**TOWN OF PORTOLA VALLEY  
ARCHITECTURAL AND SITE CONTROL COMMISSION (ASCC)  
Tuesday, May 27, 2014  
Special Field Meetings (time and place as listed herein)  
7:30 PM – Special ASCC Meeting  
Historic Schoolhouse  
765 Portola Road, Portola Valley, CA 94028**

**TO:** ASCC  
**FROM:** Karen Kristiansson, Interim Town Planner  
Carol Borck, Assistant Planner  
**DATE:** May 23, 2014  
**RE:** Agenda for May 27, 2014 ASCC Meeting

**FROM:** Carol Borck, Assistant Planner

Project No.: 10-213  
 Title: The Khato Residence  
 A101

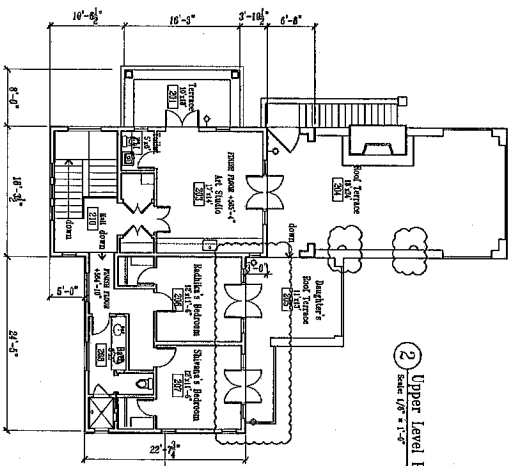
Compliance with required yard setbacks is demonstrated on Sheet A101. The proposed house is set back an additional 20 to 27 feet into the site from the required 50-foot front setback.

The project proposes the removal of a six-inch and a 12-inch oak as indicated on Sheet A101. The six-inch oak must be removed with construction of the septic system, and the 12-inch oak lies very close to the master bedroom wing. There is also a clumping of shrubs/oak bushes that will be removed with the development of the new driveway. The existing chicken coop in the rear yard is proposed to remain. Decomposed granite paths are proposed from the home's terrace downslope to access the chicken coop and a small gathering area at the 24" oak.

Proposed landscape lighting is presented on Sheet A101 and includes step/wall lights and pathlights. The proposed pathlights have a copper finish, accommodate a 10-watt bulb, and appear located in compliance with lighting guidelines. There are only three proposed pathlights in the rear yard facing neighbors on Dos Loma Vista. Other pathlights are strategically placed along side and front yard paths. Nine wall lights are proposed on the driveway retaining walls, with most facing into the site. While the proposed fixture conforms to Town guidelines, the Town typically discourages lighting along driveways.

**2 Upper Level Plan**  
 Scale: 1/8" = 1'-0"

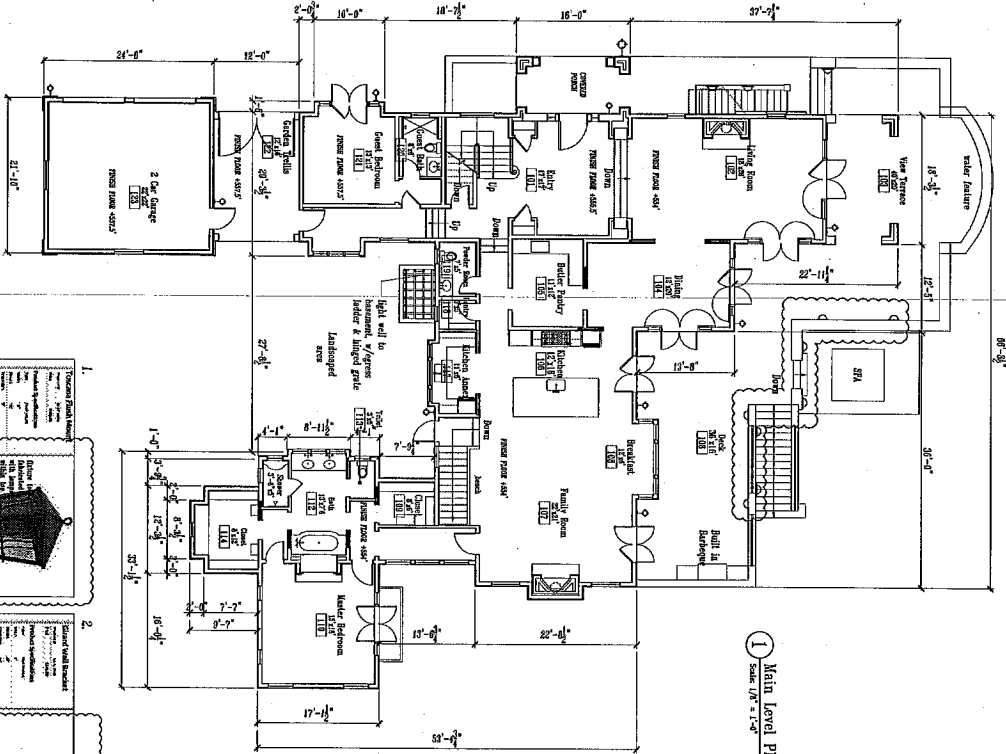
2. **Revised exterior and landscape lighting plans.** Exterior lighting for the house is shown on Sheet A201. The proposed lighting has been modified from the original submittal with the addition of one sconce light at the daughter's roof terrace, two wall lights on the roof terrace, two wall lights in the spa area, two wall lights at the view terrace, and two wall lights at the deck off of the kitchen. Cut sheets for proposed exterior lights are also presented on this sheet and clarify that the sconce and pendant fixtures will be manufactured such that the bulb will sit up within the top canopy of the fixtures and not be visible. As suggested at the 4/28 meeting, the applicants did consider placing the north elevation porch lights within the railing; however, their preference is to propose the lighting on the exterior wall as shown. While the proposed exterior lighting plan appears to be in general conformance with Town lighting guidelines, consideration should be given to reducing the newly proposed wall lights in the terrace and deck areas to one light in each area, rather than two.

**Exterior lighting.** The proposed exterior lighting for the main residence is shown on Sheet A201 and cut sheets are attached. The proposed sconces have a black rust finish, accommodate one 75-watt max bulb, and have seeded glass. The building code requires that any door leading to grade have one light, and the plans reflect this requirement. This is of particular importance on the home's eastern elevation facing neighbors on Dos Loma Vista Lane so that potential off-site exterior lighting impacts are kept minimal. There is one proposed light at the upper terrace for the art studio (front elevation), however, that is not required by code and could be eliminated.

Regarding the sconce fixture glass, although it is seeded, cut sheets appear to indicate that the source of light will still be visible. In order to comply with the lighting guidelines, the glass should be frosted or acid washed so that the bulb will not be visible. The dark bronze, eye-lid style step/wall lights for the home's exterior stairs will accommodate up to a 50-watt bulb and appear in compliance with Town lighting guidelines. Proposed guest house lighting is identified on Sheet A204. One sconce is proposed at the entry as required by building code, and one is proposed at the rear balcony where it is not required by code.

5 Guest Unit North Elevation  
 Scale: 1/8" = 1'-0"

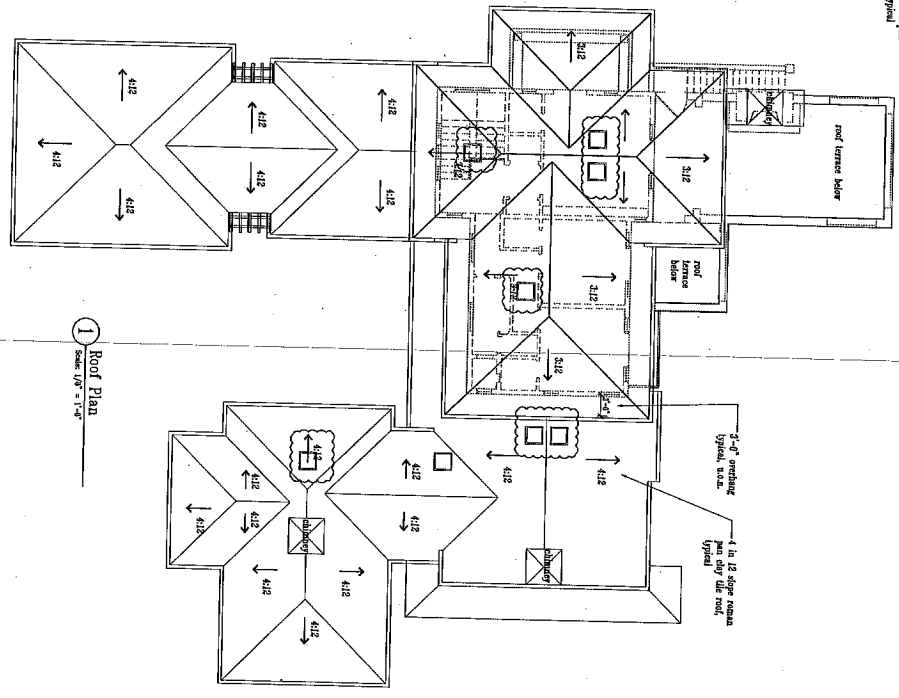
At the preliminary ASCC meeting, the project architect advised that the applicants were considering proposed skylights on the main residence. Sheet A204 identifies seven proposed skylights and specifies that these skylights will either be tinted or have automatic blinds installed. The proposed skylights are located over the entry stairs leading to the home's upper level, art studio, hallway at the childrens' bedrooms, family room, and master bathroom. The skylights with proposed light spill reduction options and their locations appear to have minimal potential for off-site impacts.

The building elevation sheet A301 for the main residence demonstrates conformity to the 28- and 34-foot height limit standards, with the maximum height of the building reaching the 34 foot limit. The guest house, shown on Sheet A204, reaches a maximum height of 24 feet on the north elevation where it extends out over the downhill slope and will need to be approved by the ASCC. The maximum permitted height of a guest house under Town regulations is 18 feet unless approved by the ASCC.

**PRELIMINARY LANDSCAPE PLAN**

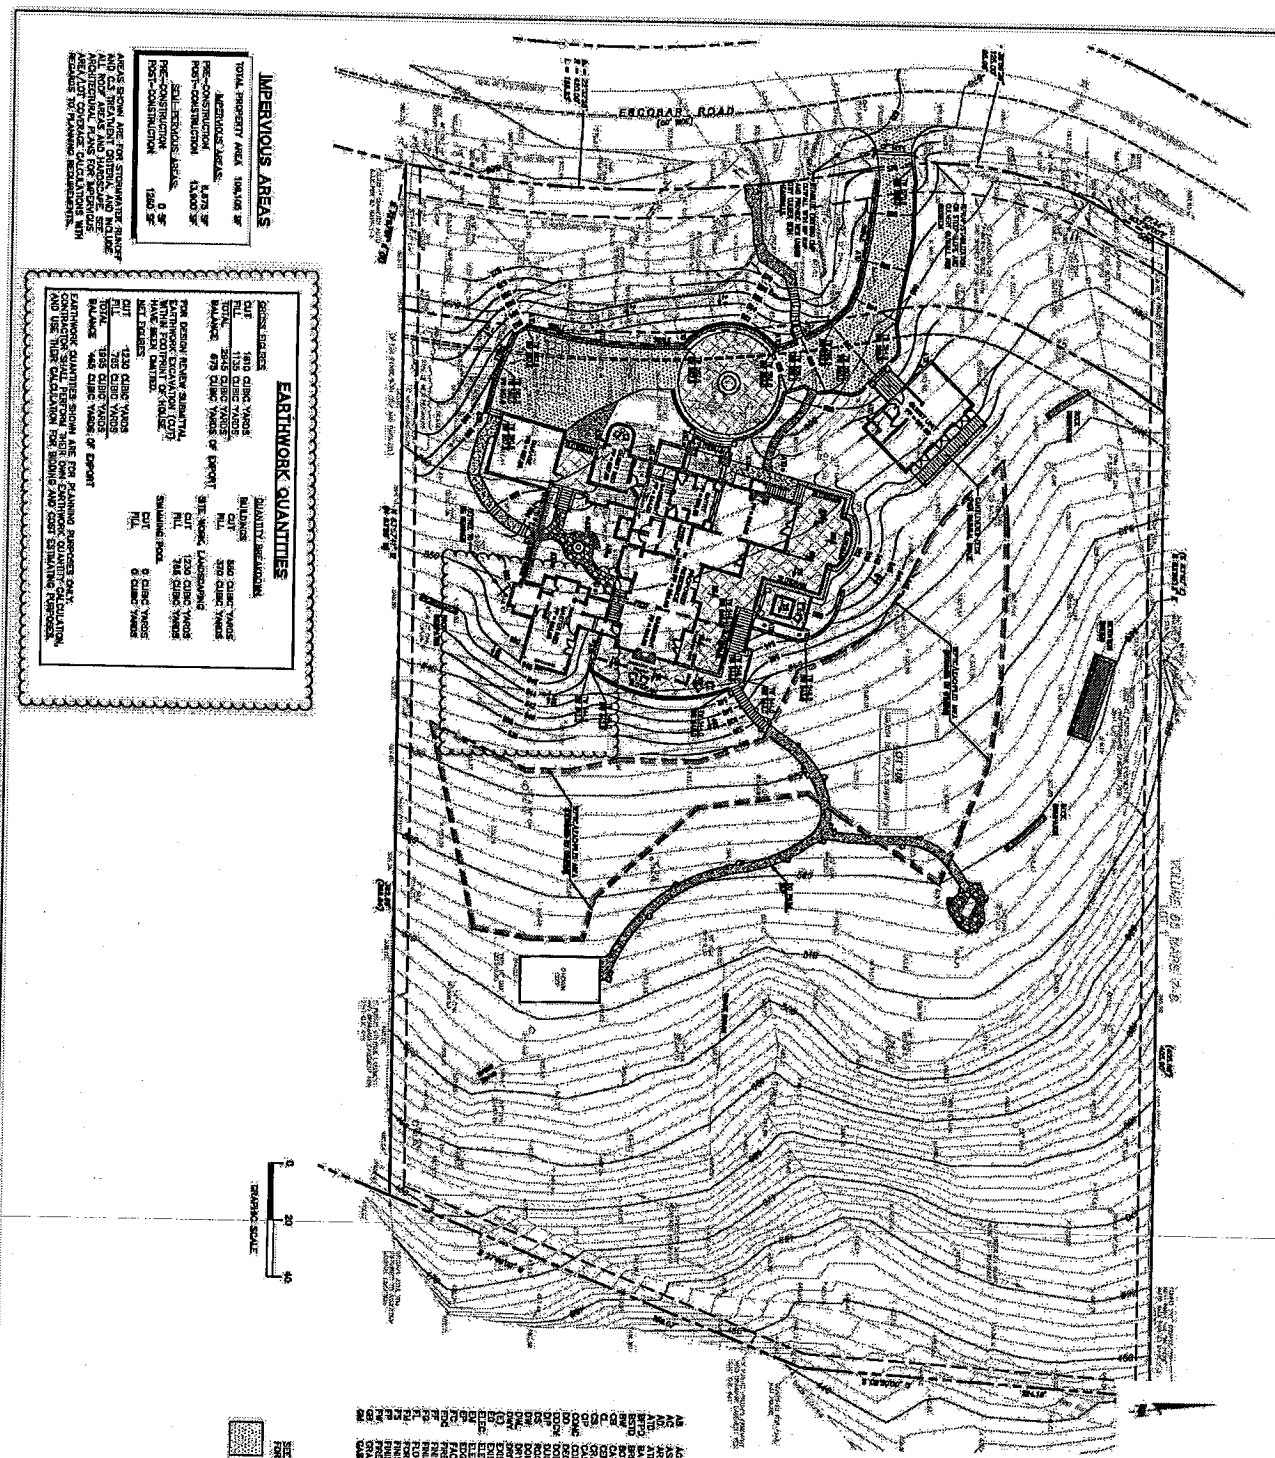
**Landscaping, fencing, and construction staging.** The proposed landscape plan Sheet L1 is preliminary and does not include a detailed plant key with sizes, numbers, and identification symbols. A preliminary plant list is provided and does not include any sod lawn, but does include Boston Ivy, an invasive that should be eliminated from the proposal. There are four screening trees proposed for the eastern elevation; however, the specific trees (and all proposed plants) and sizes need to be specified in a final, detailed planting plan. Proposed landscaping and planting is, in general, kept close to the proposed house with the majority of the site remaining in the native oak savannah. The Conservation Committee, in their attached report, makes recommendations for preserving and enhancing the undisturbed areas of the site. Control of invasives within the site's disturbed areas is also a concern.

- 5) **Landscape Drawing (L-1)**  
The landscape drawing has been modified to show native species planting and trees in the vicinity of Escobar Road.
- 6) **C2.1 Civil Drawing (Grading and Drainage Plan)**  
The grading in the vicinity of the oak trees to the east of the proposed residence has been revised per Arborist recommendations. The earthwork quantities have been updated accordingly.

SHEET  
**A1.03**  
OF 3

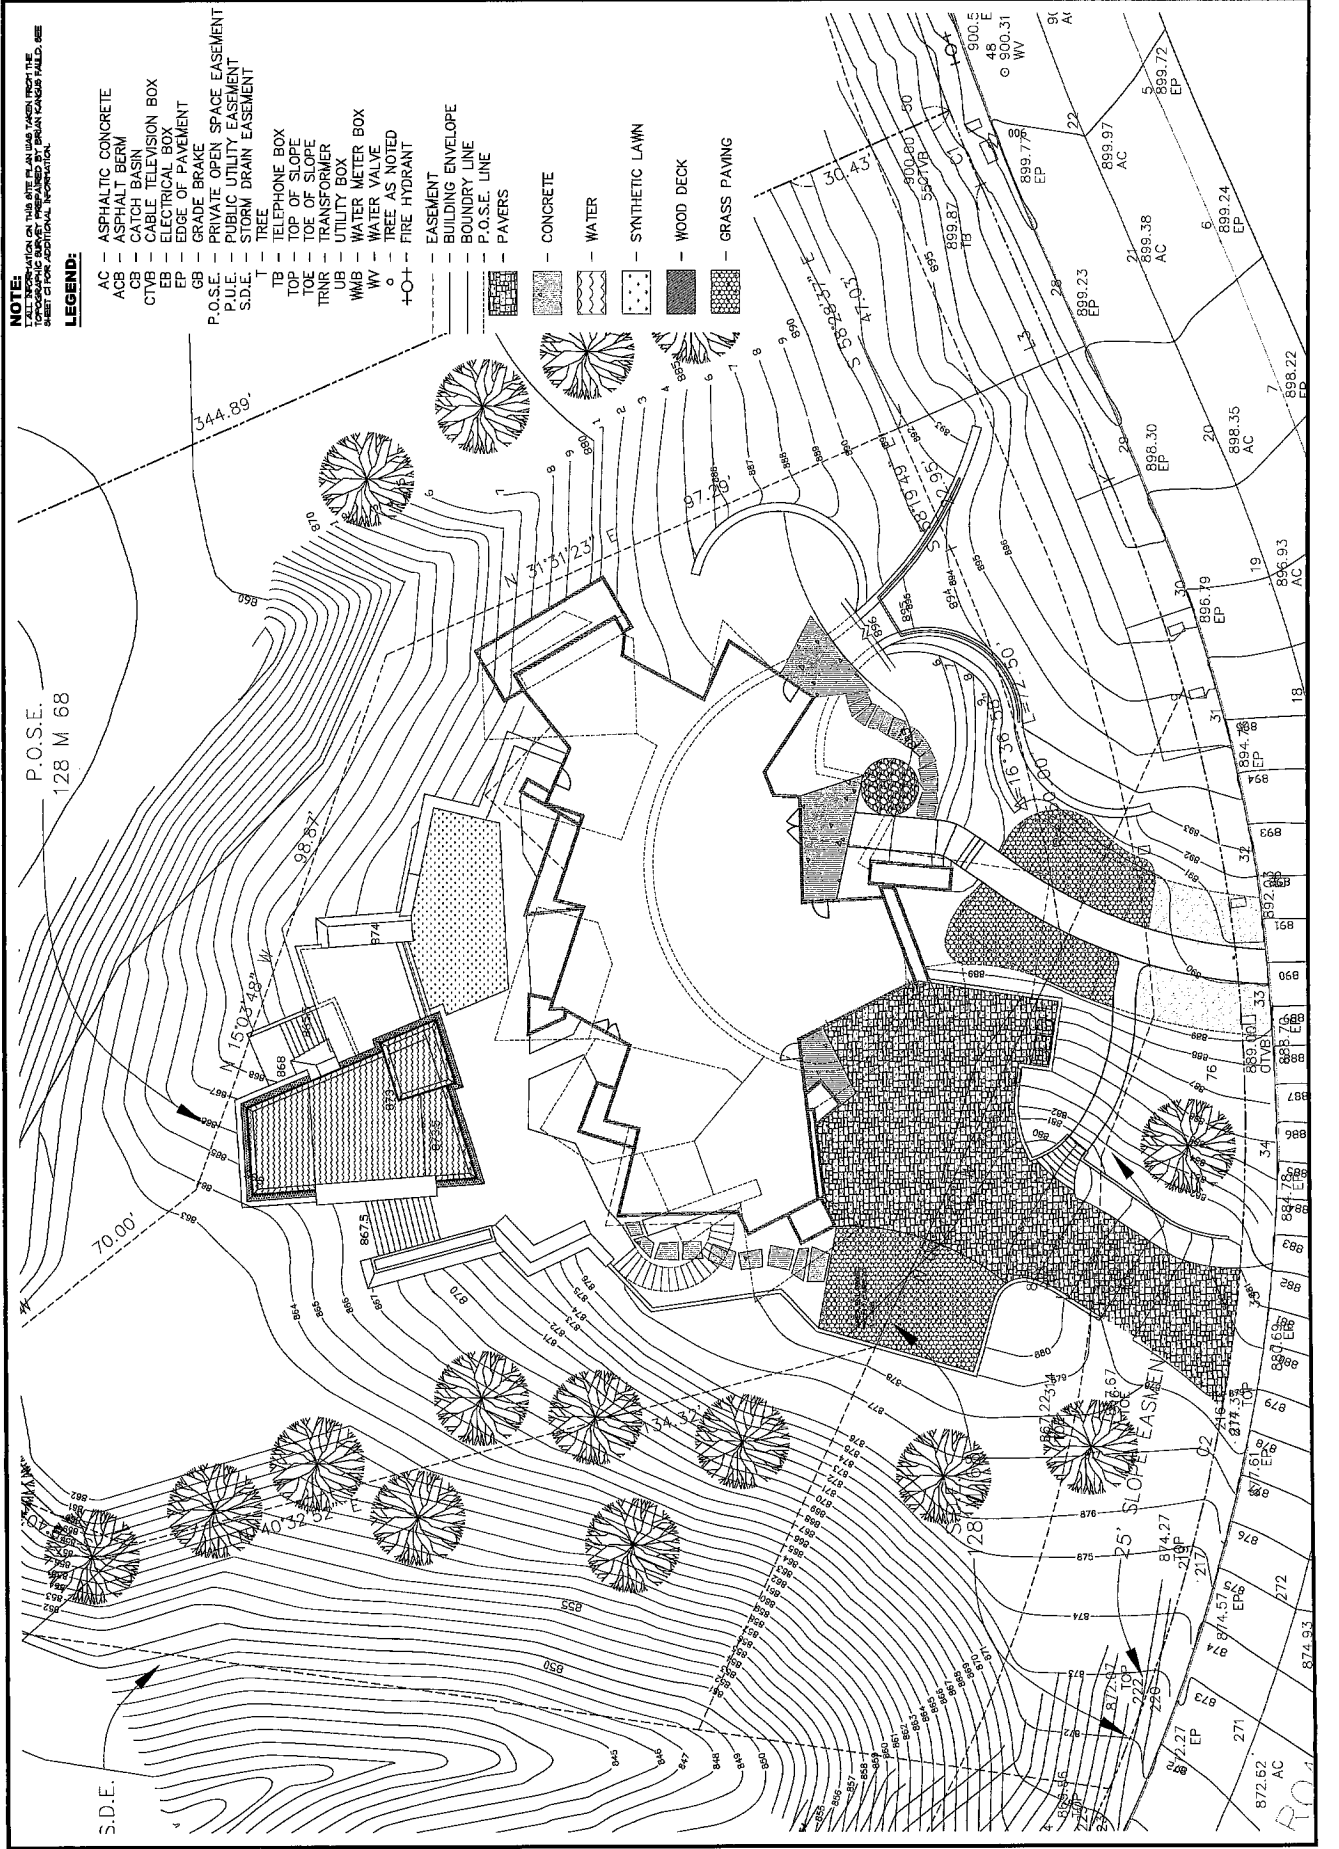
The site plan, Sheet A1.03, demonstrates that the proposal conforms to required PUD setbacks with all structures being located within the building envelope except for the trash enclosure wall.
